COUNCIL ASSESSMENT REPORT

SYDNEY EASTERN CITY PLANNING PANEL

PANEL REFERENCE & DA NUMBER	PPSSEC-341 - DA-2024/286
PROPOSAL	Integrated Development - Demolition of existing structures and construction of a twelve-storey mixed use development consisting of two commercial tenancies at ground floor level with residential co-living above, basement car parking and landscaping
ADDRESS	465-469 Princes Highway and 5-7 Geeves Avenue, Rockdale Lot A DP 306355, Lot A DP 315664, Lot B DP 315664, Lot 1 DP 131822, Lot A DP 402977, Lot B DP 402977
APPLICANT	Emag Apartments Pty Ltd
OWNER	Choi Kwan Lam Chan, Lynette Chan, Glenda Roberts, Andrew Beehag & Ian Beehag
DA LODGEMENT DATE	18 October 2024
APPLICATION TYPE	Integrated Development Application
REGIONALLY SIGNIFICANT CRITERIA	Section 2.19(1) and Clause 2 of Schedule 6 of <i>State Environmental Planning Policy (Planning Systems) 2021</i> declares the proposal regionally significant development as: General development that has an estimated development cost of more than \$30 million.

Figure 9: Excerpt from applicants' cl4.6 variation request depicting the portion of the building exceeding the building height limit and surrounding buildings

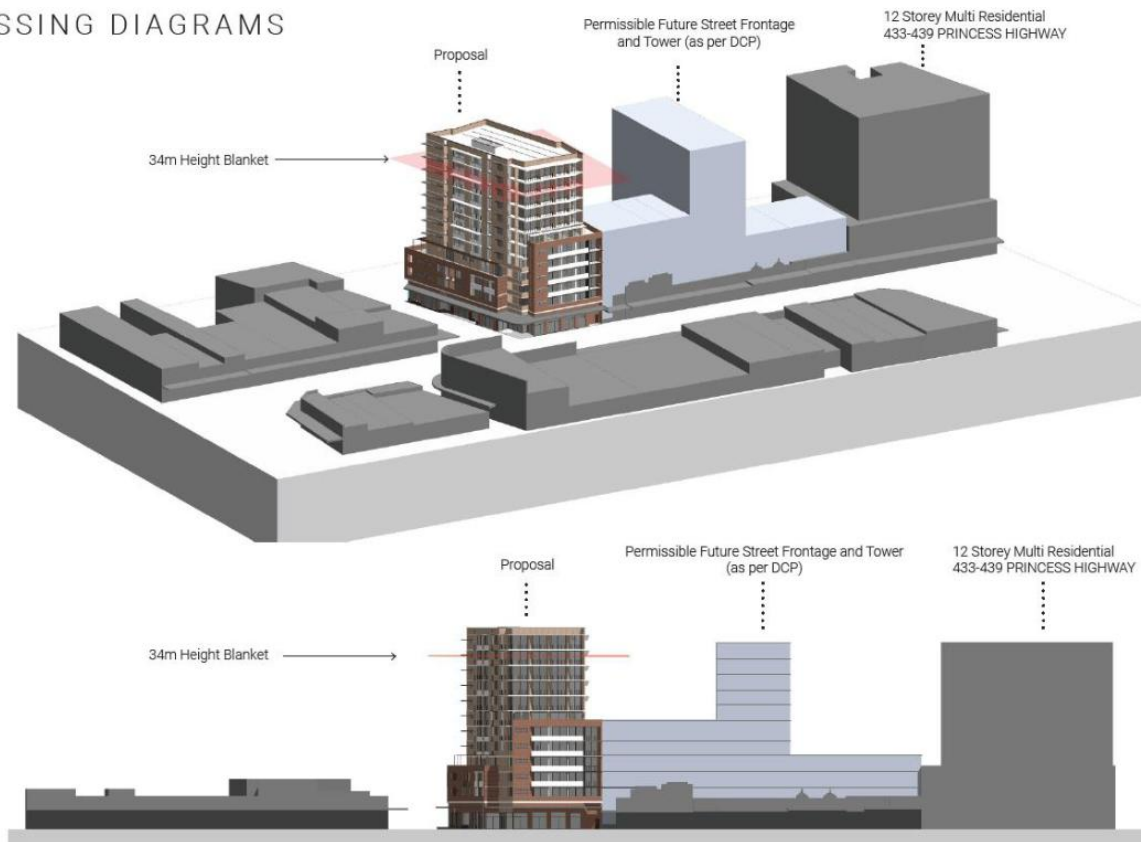
The appropriateness of the built form and land use intensity is not sufficiently justified. Council does not agree that the proposal is compatible with surrounding development and in line with the desired future character of the area.

Figure 9: Excerpt from BDCP 2022 of Figure 29: Amalgamation Pattern of the Rockdale Town Centre.

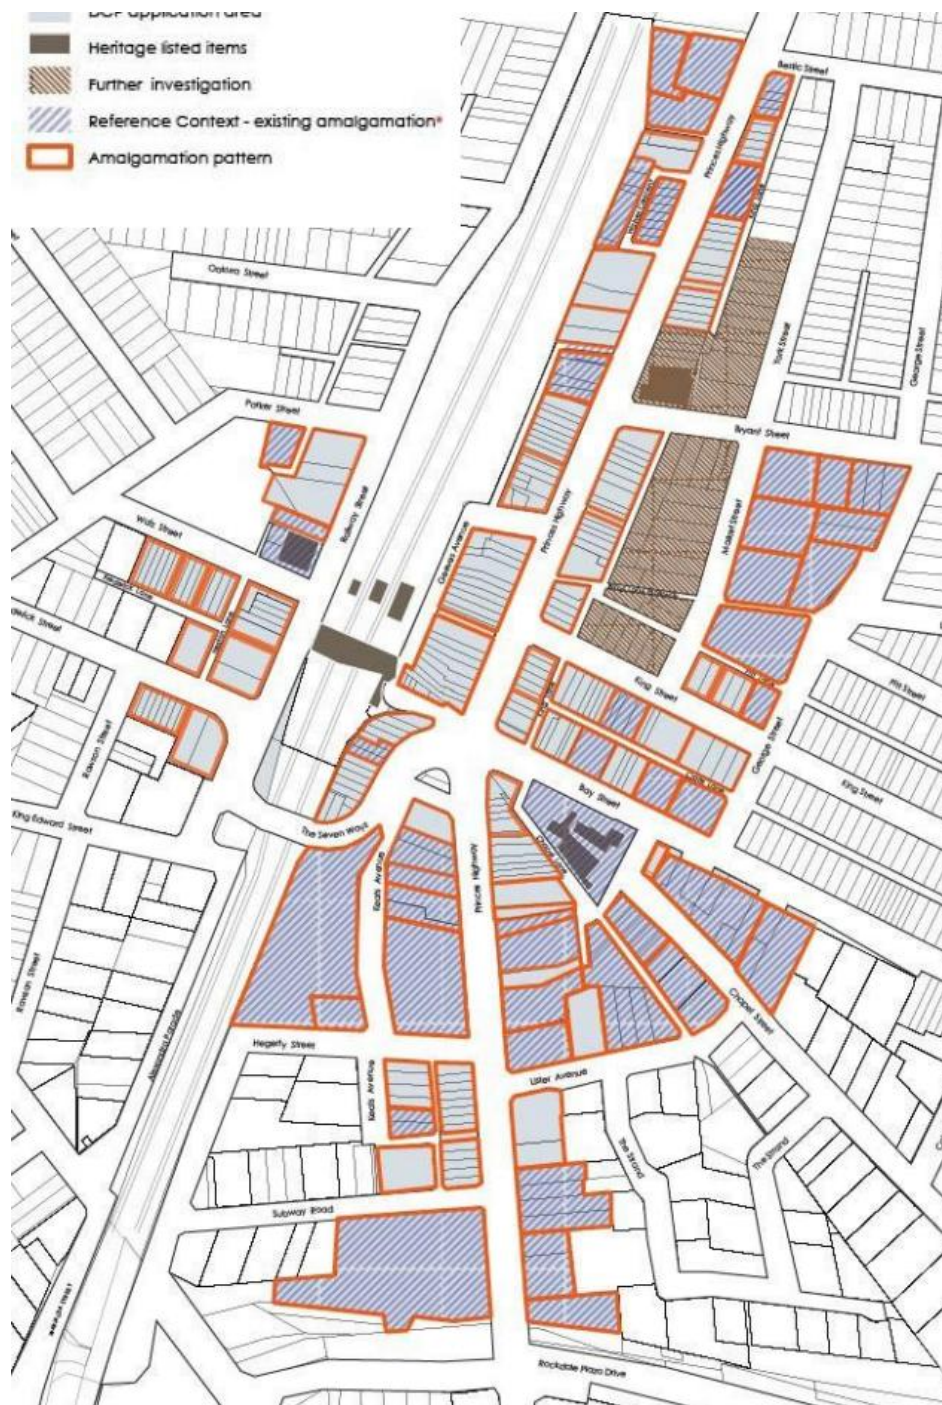
Part 7.2.5.1 depicts the desired future amalgamation patterns to achieve development consistent with other sections of the BDCP and to facilitate appropriate dwelling yields, generation of employment, and a built form that will provide a positive contribution to the spatial definition of the street. This ensures appropriate amenity is maintained for residents and future occupants.

The proposal does not provide sufficient information to support a varied amalgamation pattern which gives rise to a number of issues with amenity and building separation due to the reduced site area relative to the DCP envelope. Massing diagrams indicate future proposal opportunities to neighbouring sites in favour of their own proposal. These representations are not necessarily accurate as the indicated building envelope is indicative only and is linked to the intended amalgamation site extent.
